UNITED STATES PATENT AND TRADEMARK OFFICE

10/800,280

| Office Action Summary | Application No. 10/800,280 | Applicant(s) NEAL ET AL. | |

DETAILED ACTION

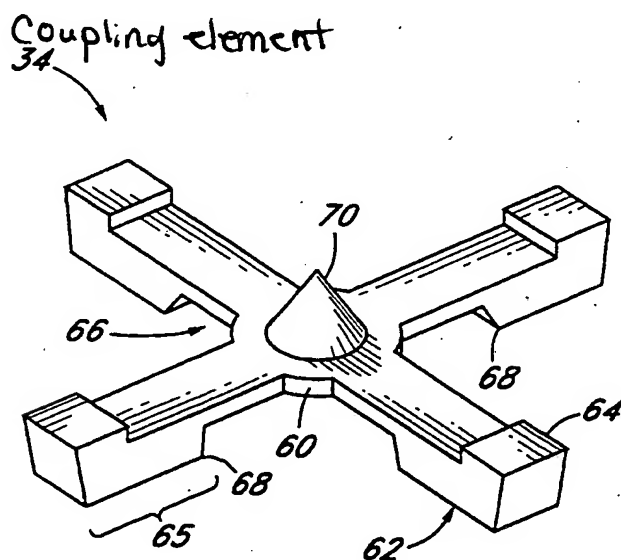
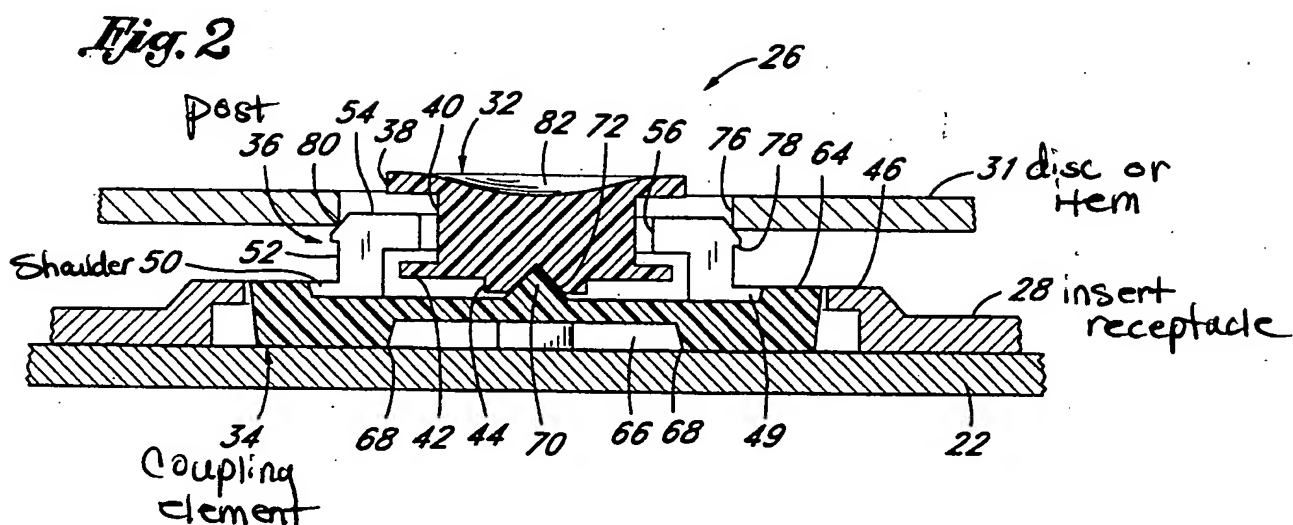
Claims 1-3, 6-12 & 14 & 16-20 are rejected under 35 U.S.C. 102(b) as being anticipated by anticipated by Kaminski US 5400902. Note: See attached figures 2,3 & 5 of Kaminski for elements representing claimed limitations in the instant application.

Note: In regards to the claimed limitations: a post comprising a body, and the body comprising first and second components of the instant application, the Prior Art Kaminski details a post (36) comprising a body (see, body of post (36)), the body (see, body of post (36)) comprises first and second components (see, green notation on attached fig. 2,3 & 5 of Kaminski).

the body (see, body of components (36)) to the side (unlabeled) (see, fig. 3 & 5 for example) of the storage compartment (20) and to allow the post (36) to be pivoted as shown by two different positions (see, for example, fig. 3 for a first position & fig. 5 for a second position).

With respect to claim 3, Kaminski teaches a body (see, body of components (36)), which pivotable (see, positions shown in fig. 3 & 5) relative to the side (unlabeled) of the storage compartment (20).

With respect to claim 10, Kaminski teaches the body (see, body of components (36)) which includes a first component (see, green notation on attached fig. 5) and a second component (see, green notation on attached fig. 5), and the coupling element (34) includes: a first element operable (34) to couple the first component (see, green notation on attached fig. 5) to the side of the storage compartment (20) and to allow the first component (see, green notation on attached fig. 5) to be positioned relative to the side (unlabeled) in at least two different positions (as, shown in fig. 3 & 5), and a second element operable (34) to couple the second component (see, green notation on attached fig. 5) to the side (unlabeled) of the storage (20) and to allow the second component (see, green notation on attached fig. 5) to be positioned relative to the side (unlabeled) in at least two different positions (as shown in fig. 3 & 5).

Kaminski teaches a system for retaining an item (31), which allows a body (see, body of components (36)) to be pivoted (see, two different positions of fig. 5 of Kaminski) and a coupling element (34) operable to couple the body (see, body of components (36)) of a storage compartment (20).

With respect to Applicant's argument, regarding the patentability of claim 1,11,14 & 21, the Examiner respectfully disagrees and notes that Kaminski teaches a post, which comprises a pivotable body, as shown in fig. 5 of Kaminski. Thus, all limitations of the instant application is met and the not in condition for allowance.
